ZBA MEETING PACKET

05/30/23

- I. CALL TO ORDER:
- II. APPROVAL OF THE AGENDA:
- III. APPROVAL OF THE MINUTES:
- IV. SURFSIDE CROSSING FINAL SITE PLAN/ENGINEERING REVIEW AND REVIEW OF CONDITIONS
- V. OTHER (VOTES MAY BE TAKEN)
- VI. ADJOURNMENT (VOTE WILL BE TAKEN)

Chessia Consulting Services, LLC has reviewed the submittal data provided to us regarding the above referenced project. The project was submitted under Chapter 40B as a Comprehensive Permit application and was approved by the Zoning Board of Appeals (ZBA) on June 13, 2019 with numerous conditions. The Applicant appealed the Board's Decision and the Housing Appeals Committee (HAC) issued a Decision on September 16, 2022 that struck several conditions, modified other conditions and added some additional conditions.

COMMON SPACE
PLANTING PLAN

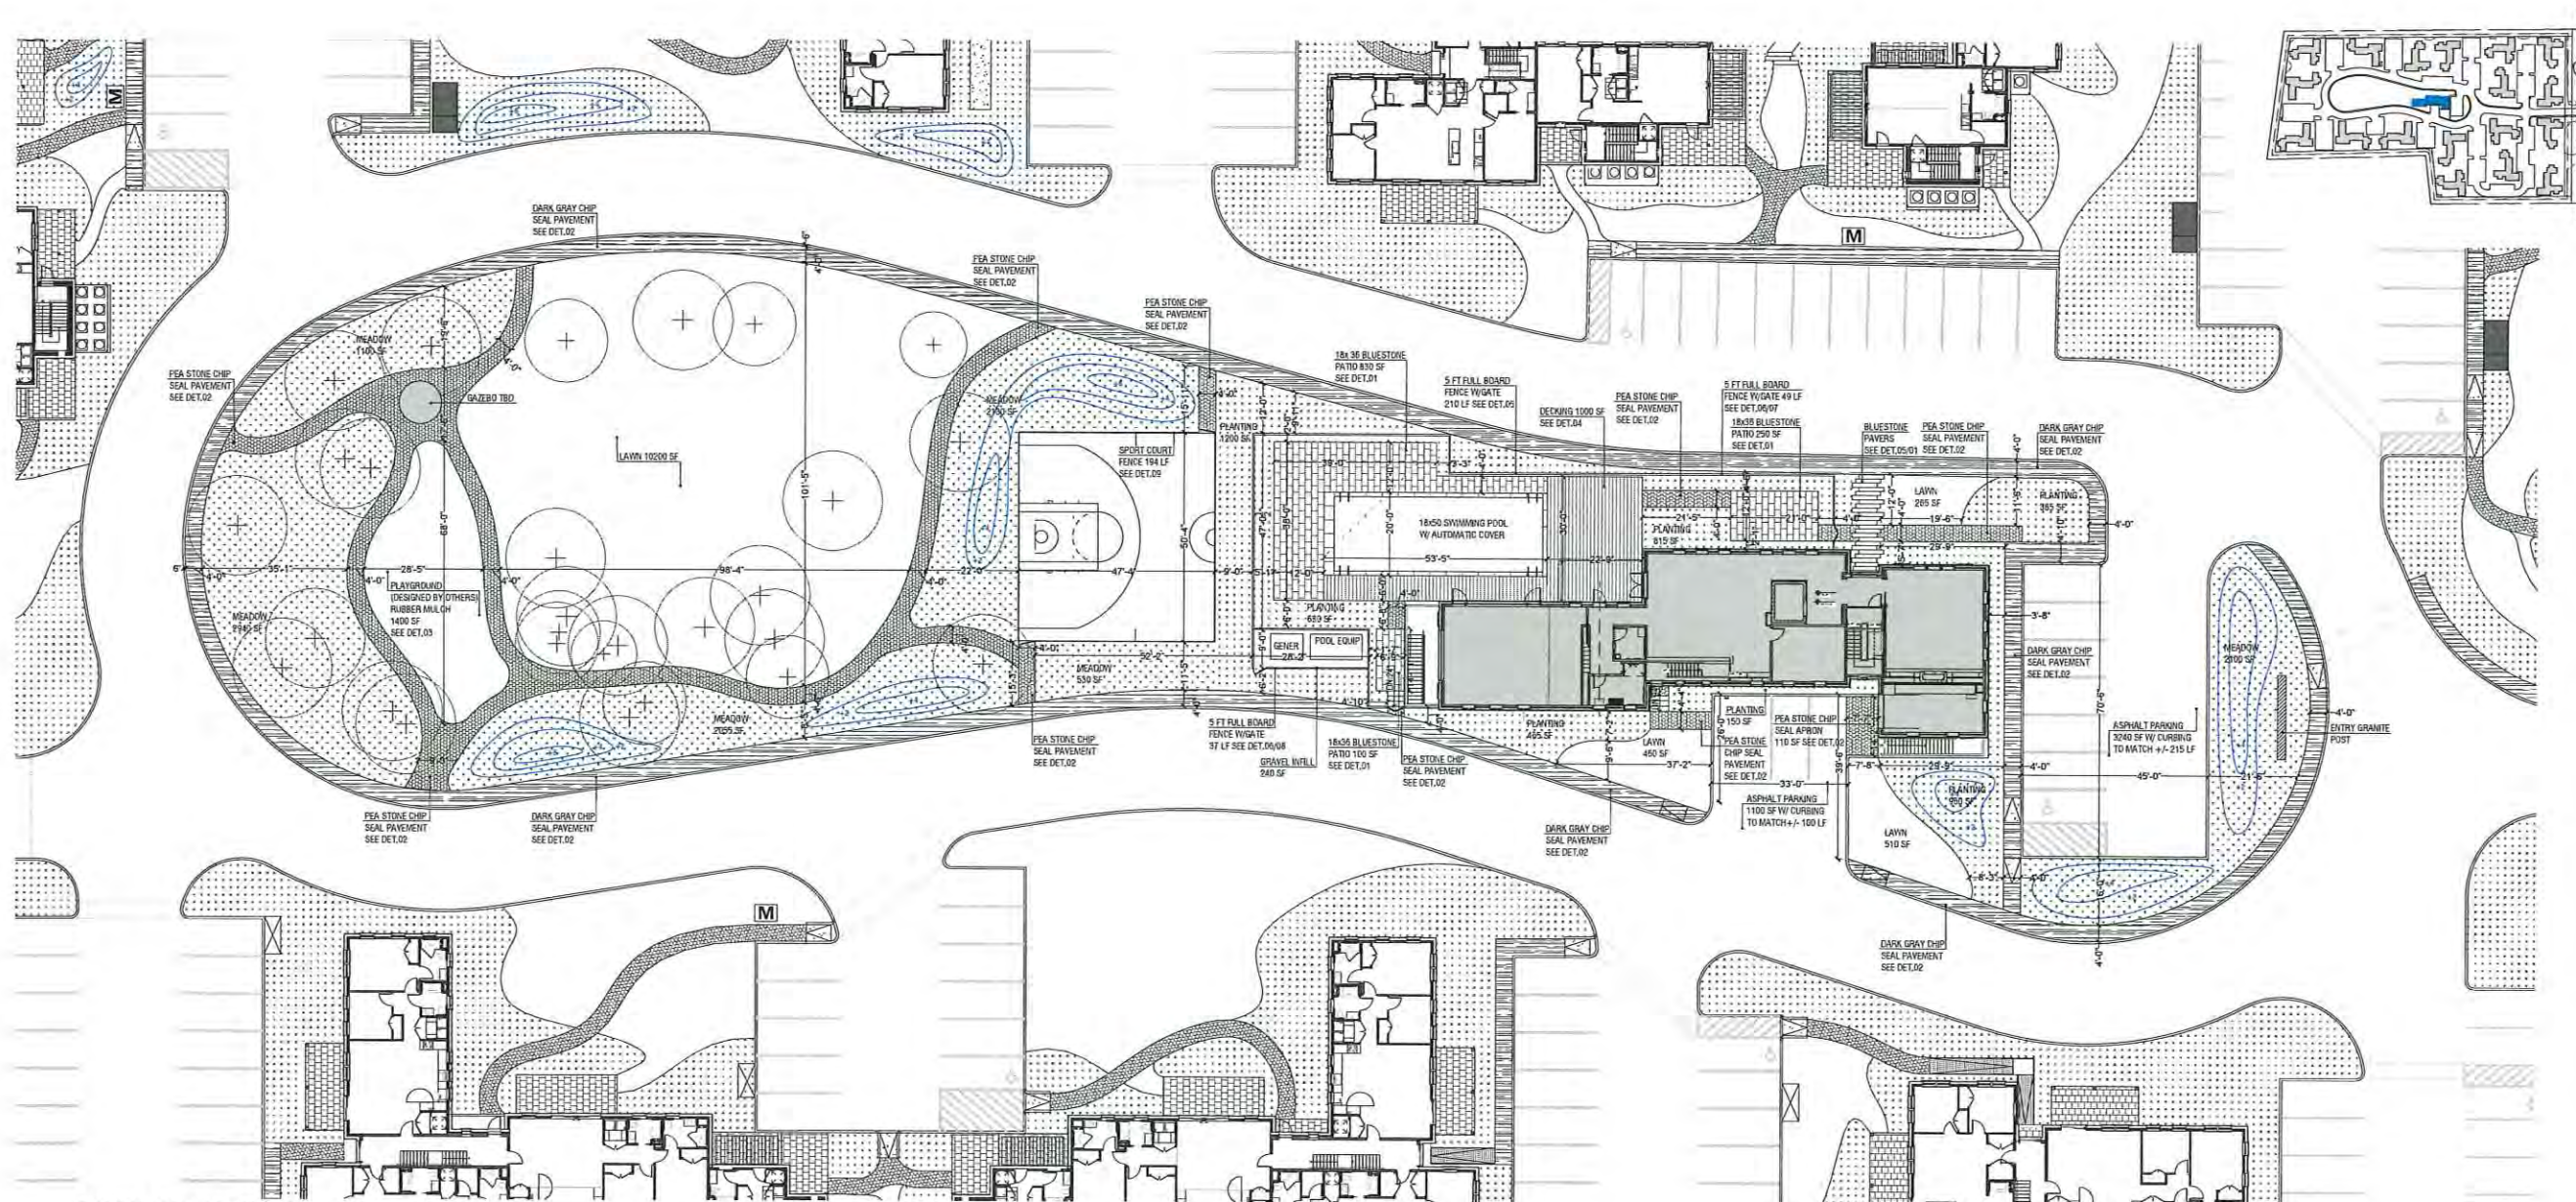
Based on my review this would be met by the Landscape Plans as there are 150 trees proposed, 7 of these are in the vicinity of the common area, the remainder (143) would be near an access drive or parking area.

No new trees are indicated on the Landscape Plans in the perimeter buffer area.

No new trees are indicated on the Landscape Plans in the perimeter buffer area.

BEI: Perimeter vegetated buffer has been staked and a post and rail fence has been installed to delineate the vegetated buffer. The buffer consists of existing vegetation which is not to be disturbed. Disturbed areas to be re-vegetated as shown on the provided Landscape Plans.

BEI: Plans will be certified by a Massachusetts licensed Landscape Architect.
